NUMBER D2-14826

TITLE TECHNICAL FACILITY CRITERIA FOR THE MINUTEMAN LAUNCH
FACILITIES - FRANCIS E. WARREN AFB, WYOMING (U)

The technical facility criteria document for the Minuteman Launch Facilities at Francis E. Warren AFB is issued as a supplement to the Wing III Launch Facility criteria presented in Boeing Document D2-13797. The complete Wing V Launch Facility criteria consists of the following:

FWAFB LAUNCH FACILITY
LAUNCHER EQUIPMENT ROOM
PERSONNEL ACCESS
SYSTEM & SIGHT TUBE
THE BOEING COMPANY

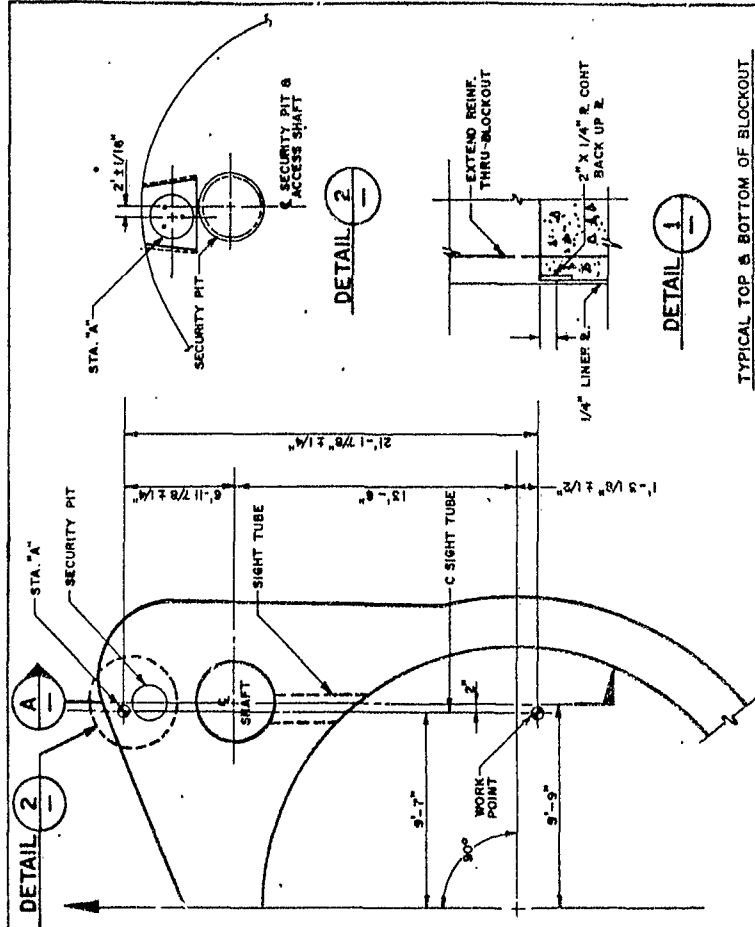
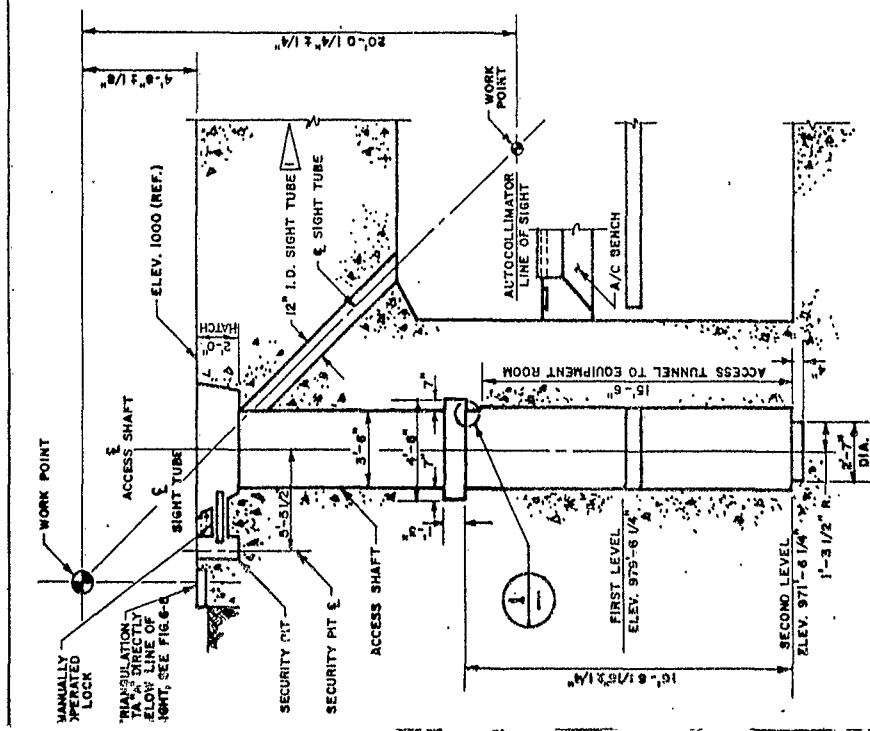
9.8.4 Figure 9-2 shows the Sight Tube inside diameter change from 24" to 12".

CALC	REVISED	DATE	FWAFB LAUNCH FACILITY	D2-14826
CHECK			LAUNCH TUBE	FIG. 10-3.1
APR			LOCATION OF SERVICE LINES	PAGE 35
APR			THE BOEING COMPANY

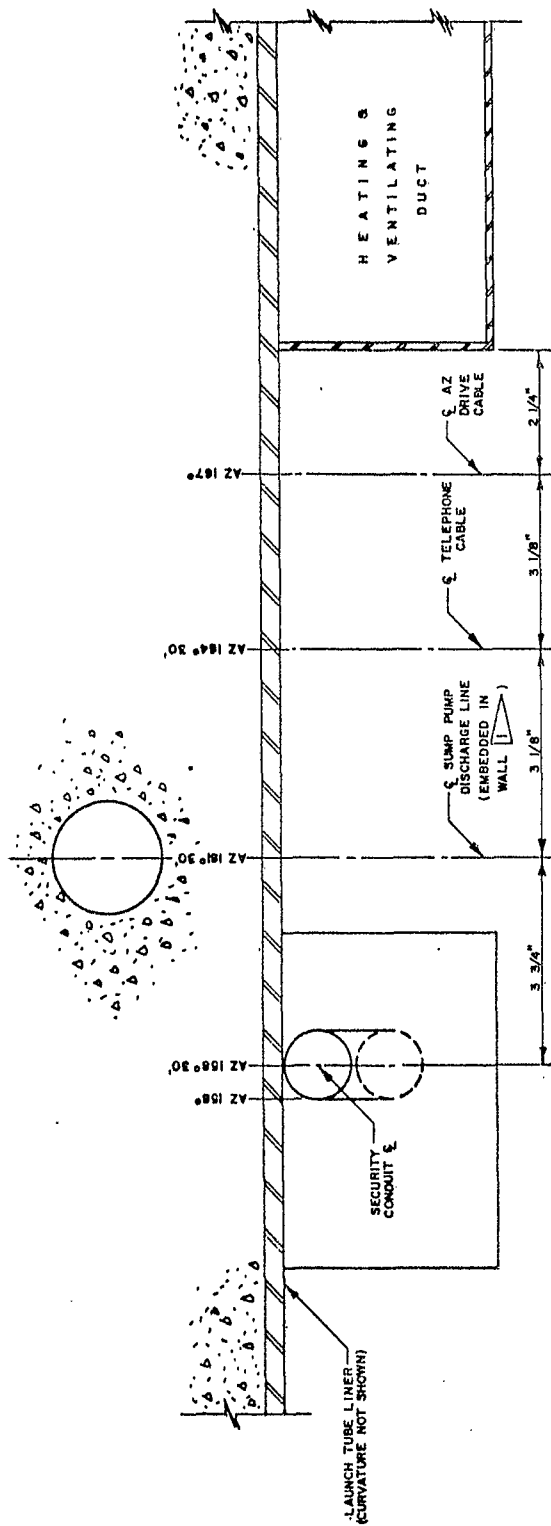
10.8.3 Figure 10-3.1 deletes Detail 1 showing minimum attachment and proximity relationships between MPT J-Box and sump pump discharge line; and shows requirement for embedding sump pump discharge line in launch tube wall.

CALC	REVIS	DATE	102-14826
CHECK			LAUNCH TUBE
APP			MISSILE SUPPORT LOADS
APP			THE BOEING COMPANY
			PAGE 37

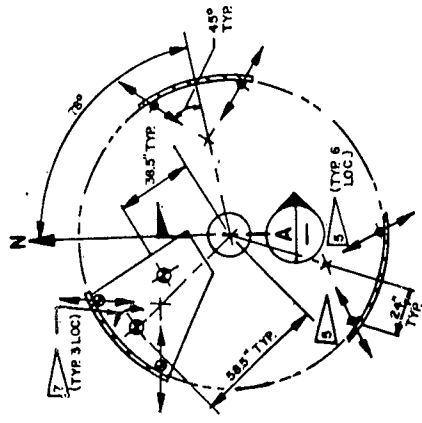
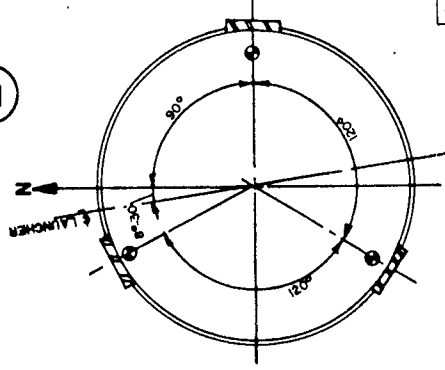
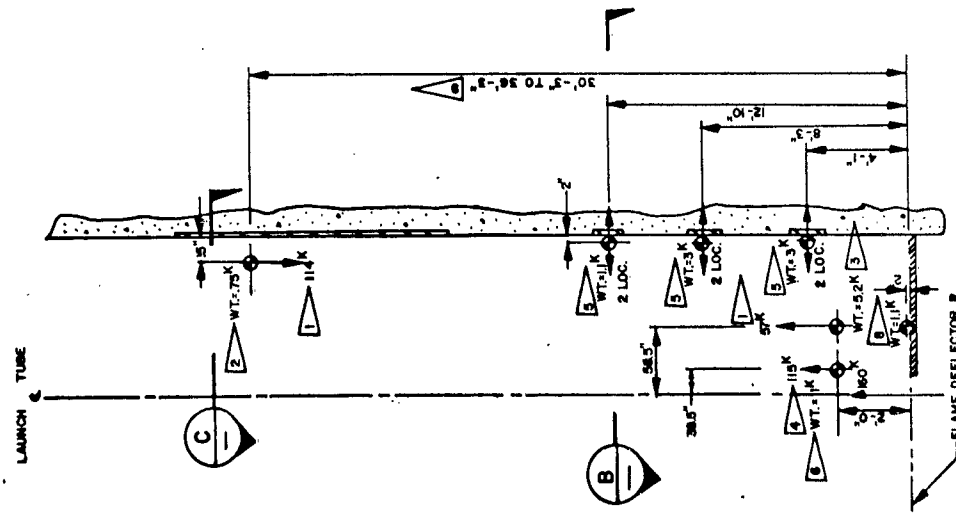
10.8.5 Figure 10-6 shows increased dimension range from deflector plate to load point at upper missile support plate from "20'-3" to 26'-3" to "30'-3" to 36'-3".
